Office of Drinking Water and Municipal Assistance
Grand Rapids District Office

Water System Sanitary Survey

City of Muskegon Heights Water System

2015

Filter Nos. 1, 2, 3, and 4

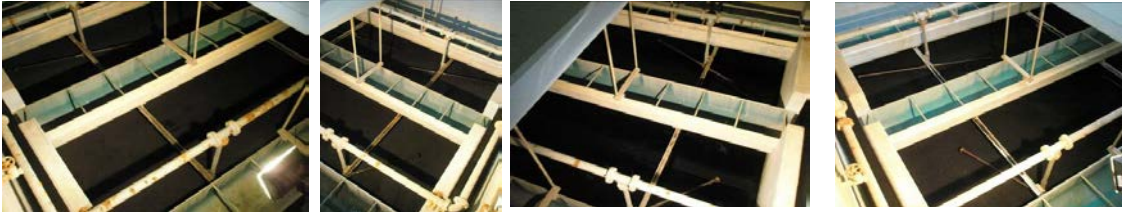
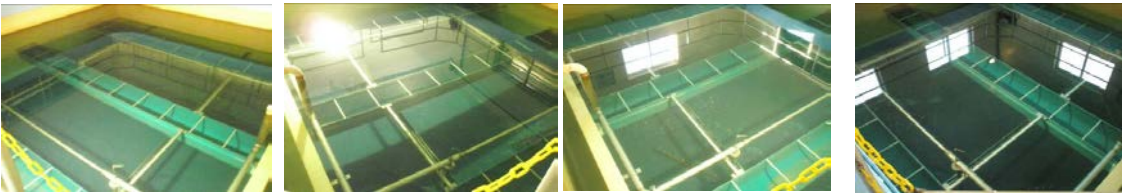
- **2014 - The anthracite in filters 1-8 will be topped off this year.**
- **2015 - The anthracite has not yet been added, planning on doing that this year.**
